400 - cont.

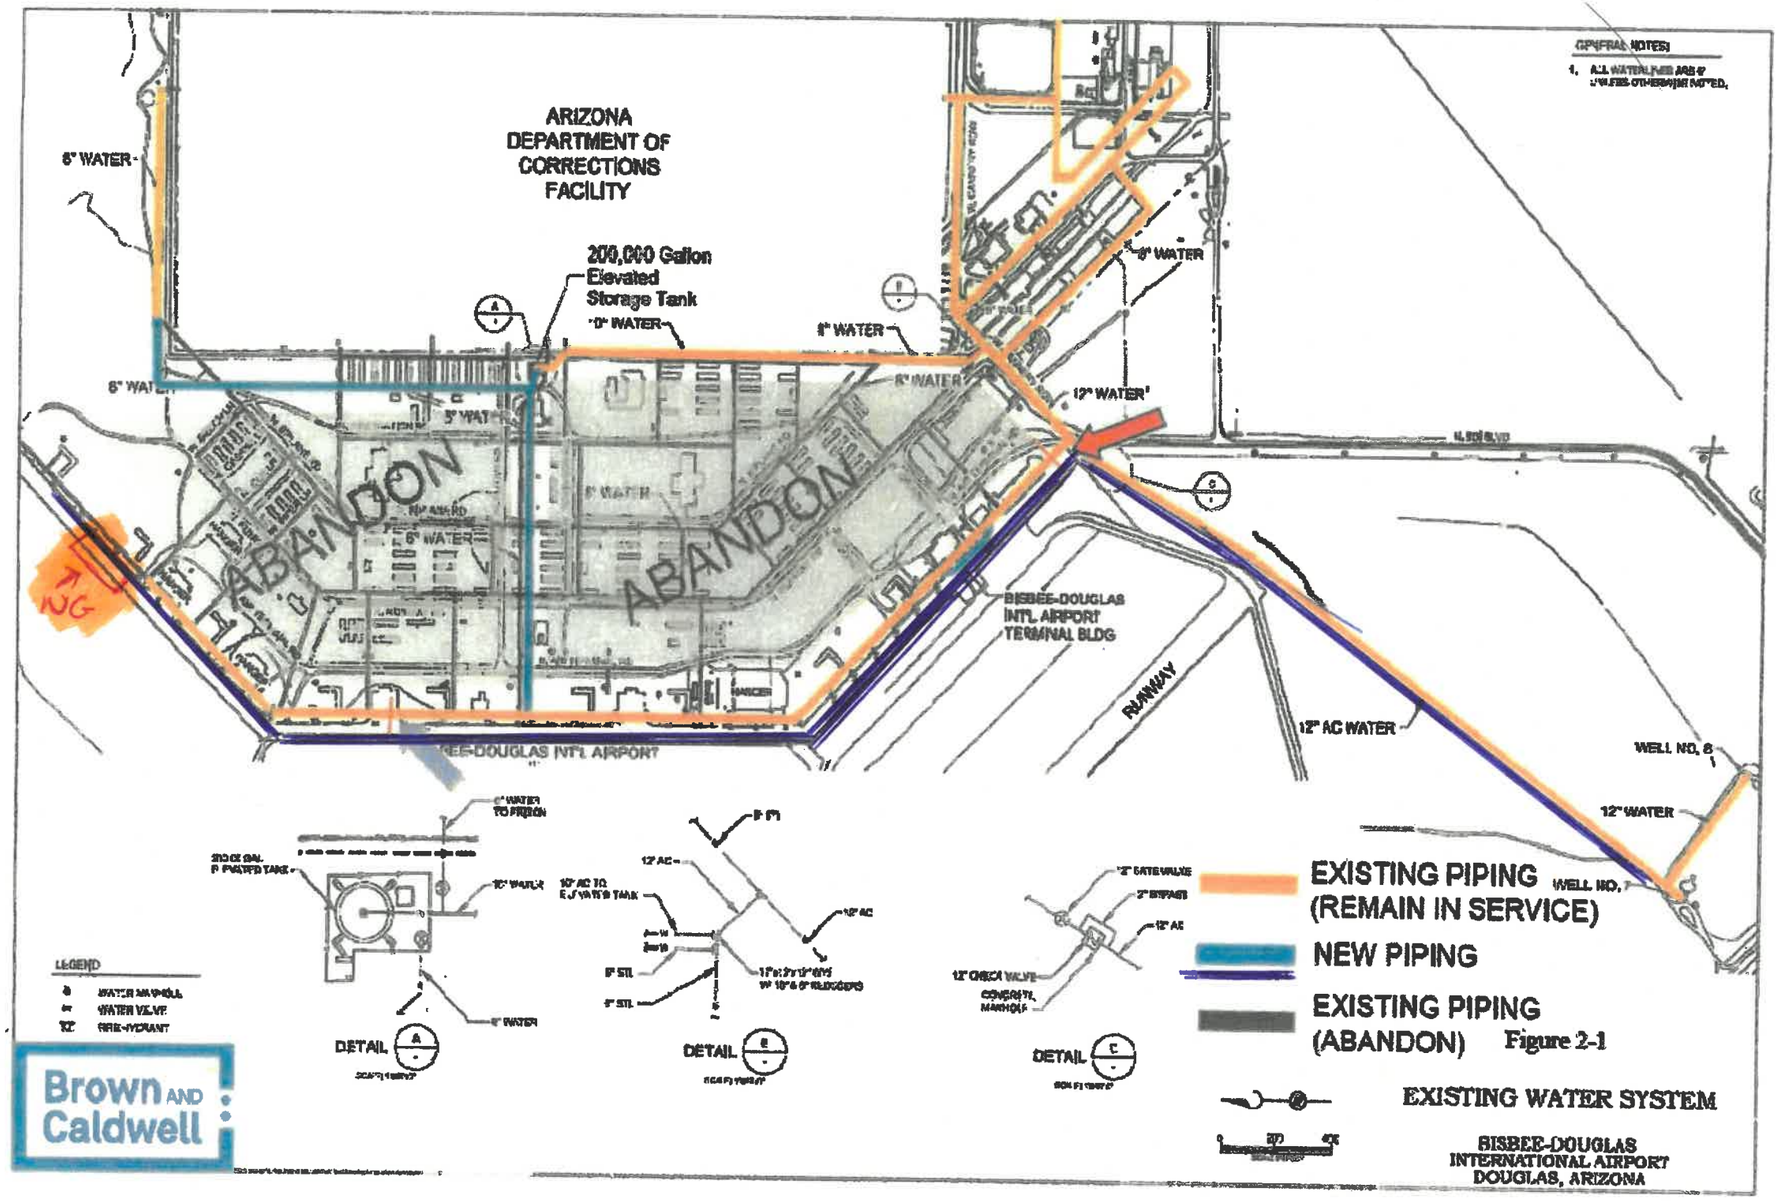
The risk of not abandoning the existing main supply line (red arrow) and replacing it with a new 6" or 8" main is too great to not at least revisit the cost of new main VS cost and liability of trying to cap all taps to existing service lines in the "Abandon" area. If we miss just one we open the door to major leaks in the interior and possibility of undermining a portion of the runway, not to mention the portion of the existing main that feeds the fire plugs on the perimeter that is reduced from 8" to 2" and back to 6". That existing reduction to 2" (purple arrow) cannot supply the proper volume of water to the fire plug past this pinch point. Not only will this portion of the project be a change order and cost overrun nightmare the end result will still be inadequate to meet the requirements for the airport and fire safety
